Appendix B

Responses to NRC Questions

Page
Responses to Questions on GESTAR II Revision 5	US.B-3
Responses to Questions on the Barrier Fuel Amendment (Amendment 6)	US.B-113
Responses to GESSAR II Questions Regarding SRP Section 4.2	US.B-120
Responses To Questions On The Fuel Loading Error Analysis (Amendment 28)	US.B-126
Responses to Questions on Additional Amendments (References)	US.B-136

Figure 5.3-2. MSIV Closure

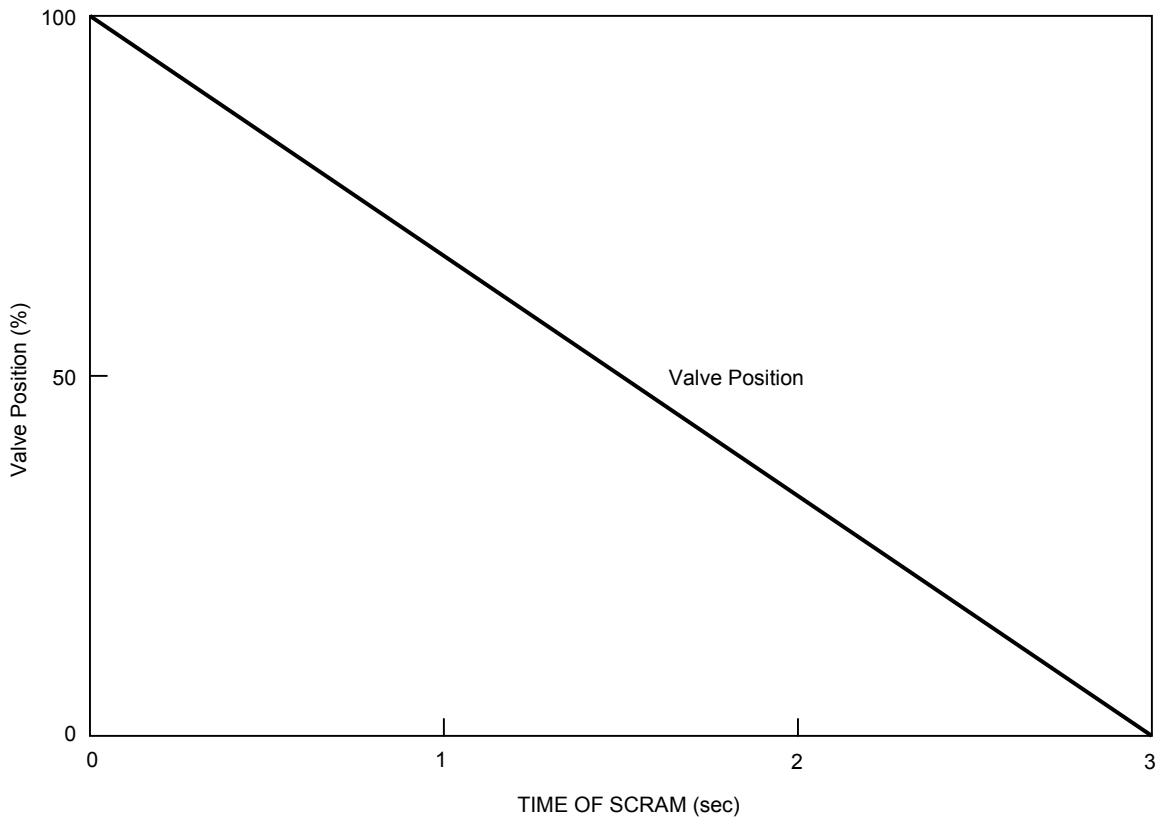
The power levels indicated in Table 5-6 are consistent with the power levels given in plant technical specifications and used as the basis for the safety analysis. The General Electric basis for code overpressure protection analysis has been documented in Reference 5-14. As noted in the response to the request on Subsection 5.2.1, GE specifically addressed the 2% adder to the initial power, to all transient analysis in Reference 1. Figure 5.3-2 shows the assumed closure rate used in this analysis.
